CITY PLANNING COMMISSION

N 090293 ZRM

IN THE MATTER OF an application submitted by SDS 15 William Street, LLC, pursuant to Section 201 of the New York City Charter, for an amendment to the Zoning Resolution of the City of New York, concerning the Special Lower Manhattan District (Article IX, Chapter 1), Appendix A, Map 5, relating to curb cut prohibitions in Community District 1, Borough of Manhattan.

A-101A

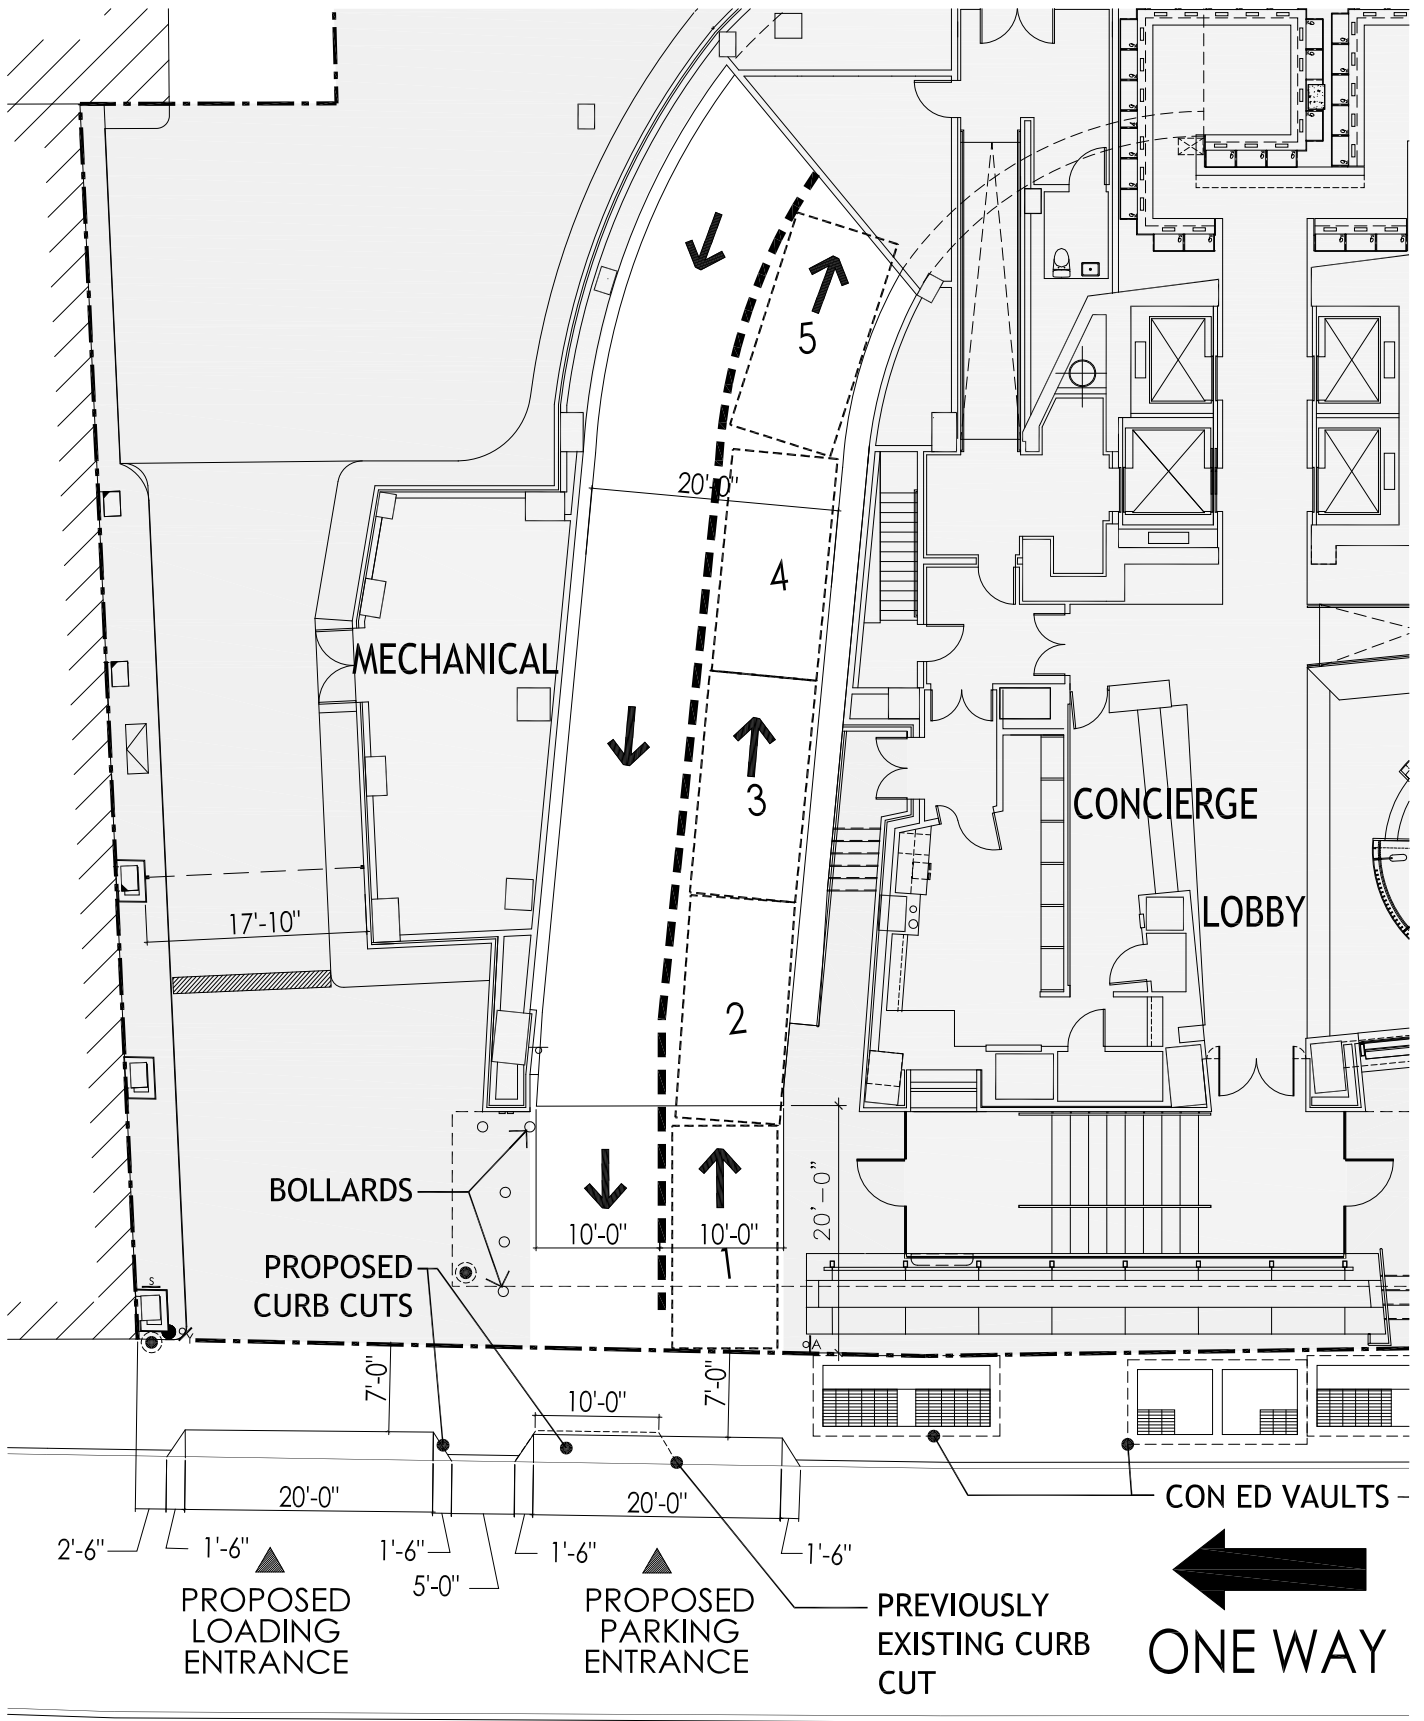
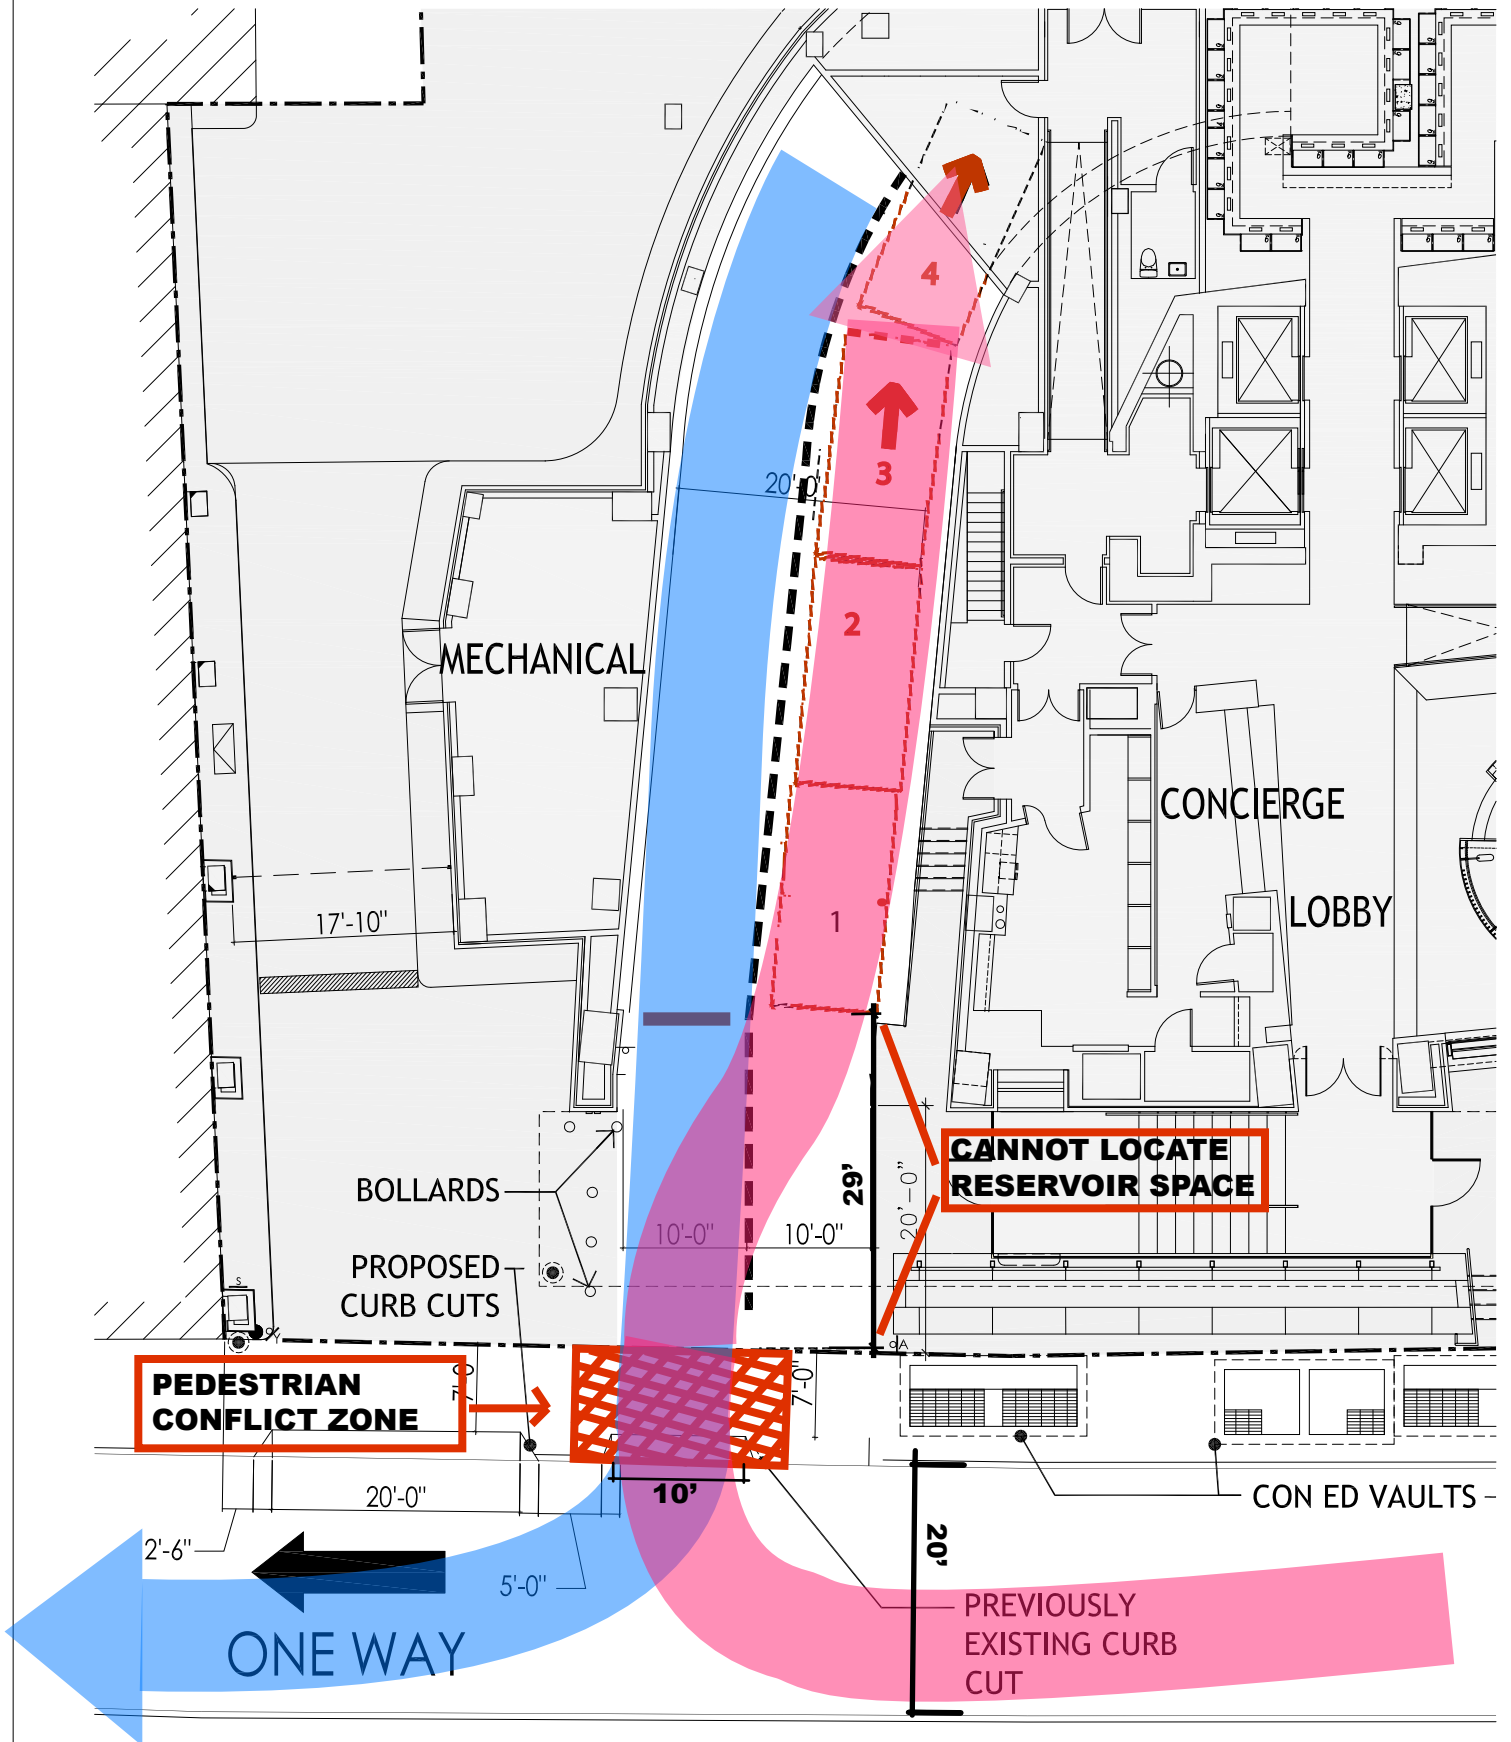
Under the application, there would be a twenty foot curb cut with access to two lanes at the garage entrance, one of which would function as the reservoir lane. Reservoir spaces would descend down the curve of the ramp and end at the attendant booth located at the mouth of the ramp leading to the 2nd cellar level. The reservoir spaces would be positioned with sufficient area to allow attendants to turn down the ramp without having to engage in complex maneuvers, such as a three-point turn.

A ten foot curb cut would require a single, shared ingress and egress lane at the mouth of the entrance to the garage. This shared ingress and egress lanes eliminates the entrance to the garage as the location for the first reservoir space. (See Exhibit A) With a ten foot curb cut, cars entering the garage have only the width of the sidewalk (9 feet 4 inches) to complete the turn. A tight turn to align the vehicle with the first reservoir space would be extremely difficult. More likely, entering vehicles would make a wider turn that would result in a crossing of the egress lane and alignment with the reservoir procession at a point past the first reservoir space. As a result,

dedicated reservoir spaces would not be functional until a distance of about 29 feet from the entrance, resulting in a loss of one, possibly two, reservoir spaces.

A-102

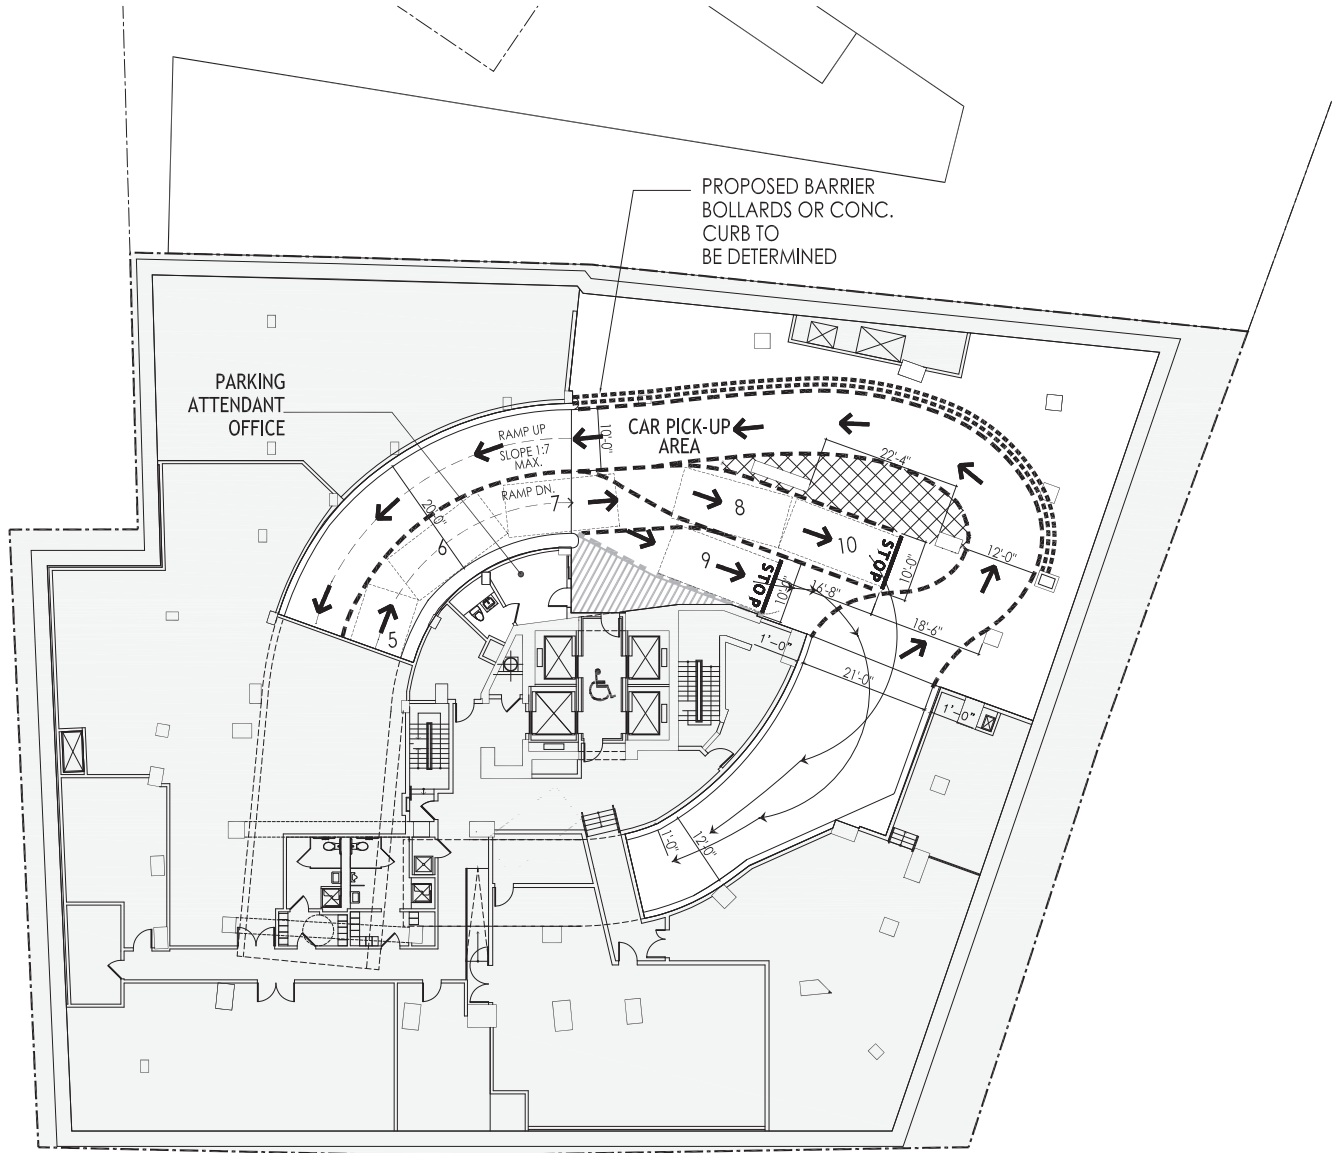
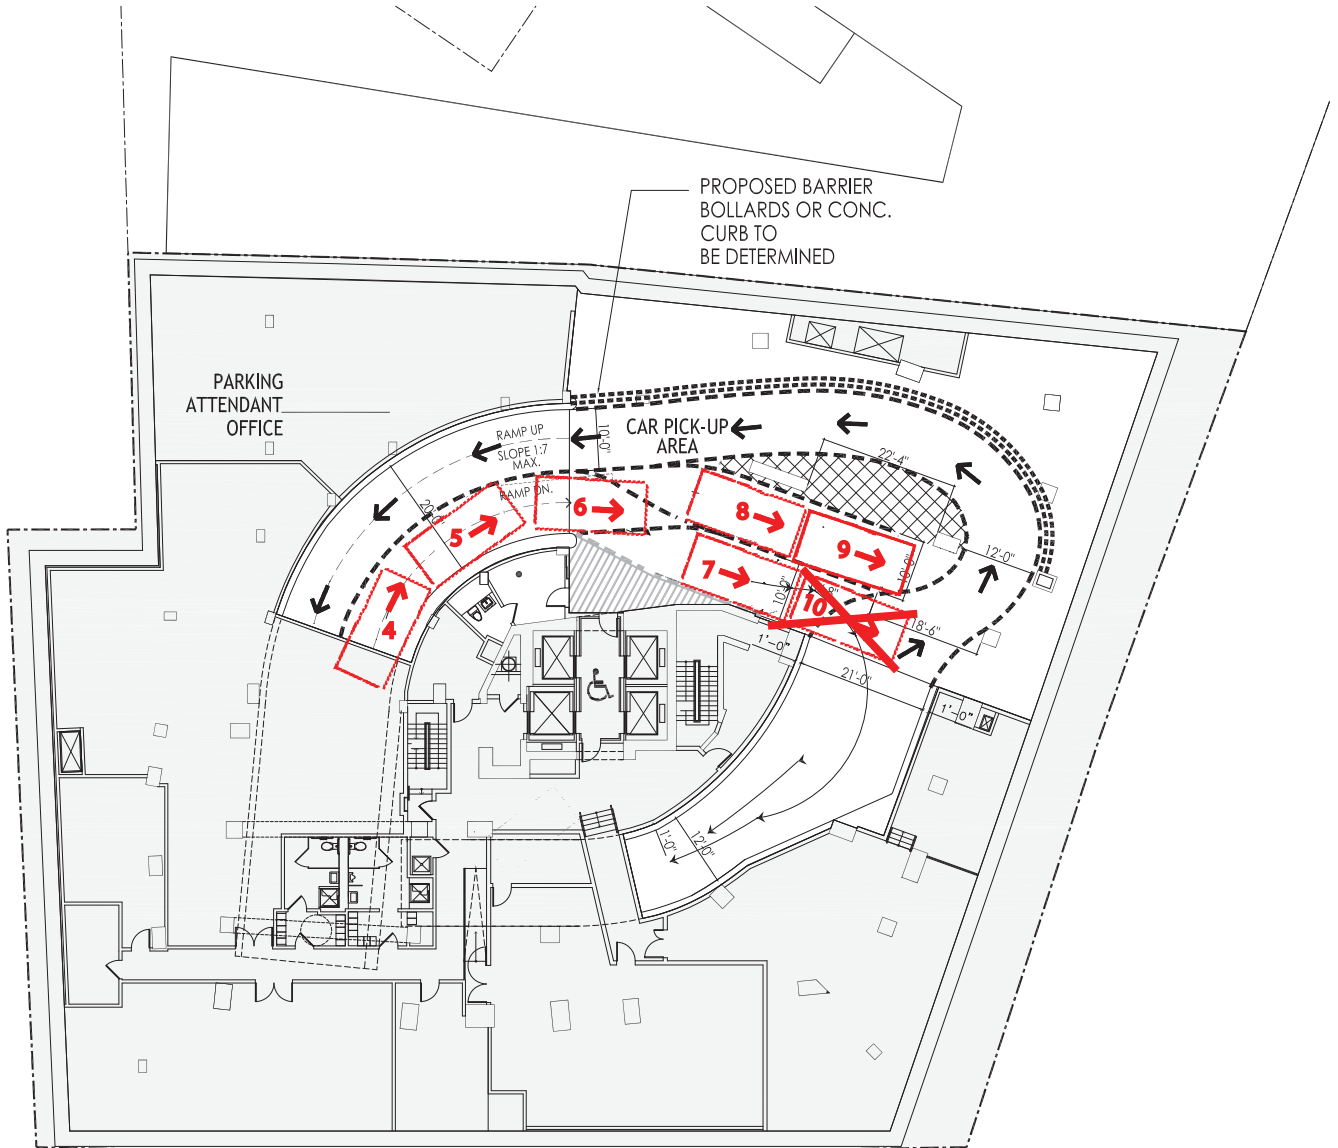
Moreover, lost reservoir spaces could not be regained at the cellar level by shifting reservoir spaces further down the ramp, as shown in the cellar level diagram (Exhibit B). The ability to shift the reservoir spaces further down the ramp, and therefore deeper into the garage, is prevented by the existing ramp leading from the 1st cellar level to the 2nd cellar level. Adding the lost reservoir spaces to this end of the queue would block access to this ramp, and a vehicle in this location would not be able to make the turn smoothly down the ramp without interfering with existing columns and building floor area. An attendant would likely have to make a three-point turn to head down the ramp, creating a potential for cellar level congestion and backup.
